# Subregional RTEP Committee – Western FirstEnergy Supplemental Projects

January 17, 2025

Need Number: (s1717)  
 Process Stage: Re-Present Solutions Meeting – 1/17/2025

# ATSI Transmission Zone M-3 Process West Chippewa 69 kV Substation

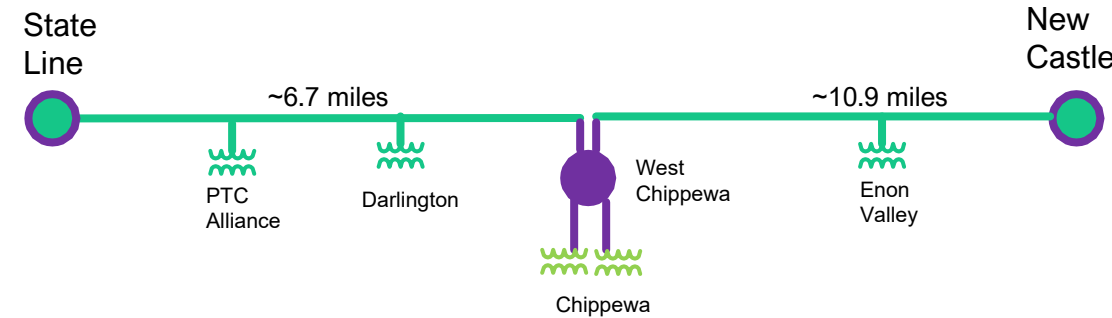
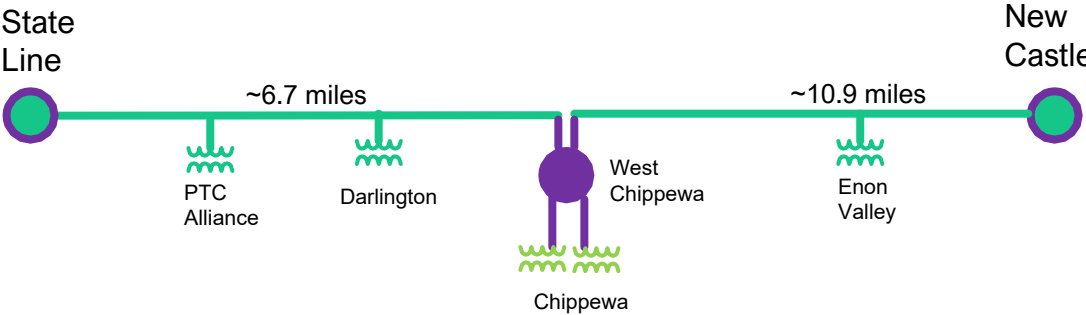
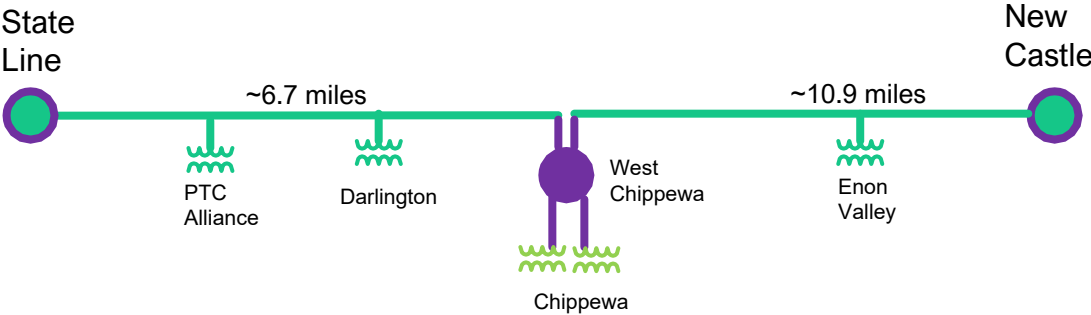
Changes are marked in red

- Construct a 5-breaker ring bus at **West** Chippewa substation
- Loop the State Line – New Castle 69 kV line in/out of the new West Chippewa 69 kV ring bus substation

- Construct a new 69 kV line from the West Chippewa tap (Structure 163) into new ring bus (~0.1 mi) as a double circuit.
  - The project splits the State Line – New Castle 69 kV Line and creates the following two lines:

- State Line – West Chippewa 69 kV Line
    - New Castle – West Chippewa 69 kV Line
- Install one ~~12.6~~15.6 MVAR cap at **West** Chippewa
- ~~▪ Rebuild approximately 2.5 miles of 477 ACSR to double circuit 69 kV line to convert radial tap to networked line and load at Chippewa substation.~~

- Construct a new 69 kV line from West Chippewa 69 kV ring bus into the existing Chippewa substation (~2.7 mi).
- Rebuild the existing 69 kV line from West Chippewa 69 kV ring bus into the existing Chippewa substation (~2.7 mi).

- Install (3) 69 kV SCADA controlled switches outside of Chippewa substation.
- Reconfigure and re-terminate at Chippewa substation as necessary to accommodate the new 69 kV line and new switches.

- Revise relay settings at New Castle & State Line substations.
- ~~▪ New Castle State Line 69 kV line is being rebuilt under separate project to 477 ACSR~~

- ~~▪ Old Rating 71 MVA SN New Rating 100 MVA SN~~

**Estimated Project Cost:** ~~\$9.1M~~-\$34 M  
**Projected IS Date:** ~~6/1/2021~~ 12/31/2025  
**Status:** ~~Conceptual~~ Engineering
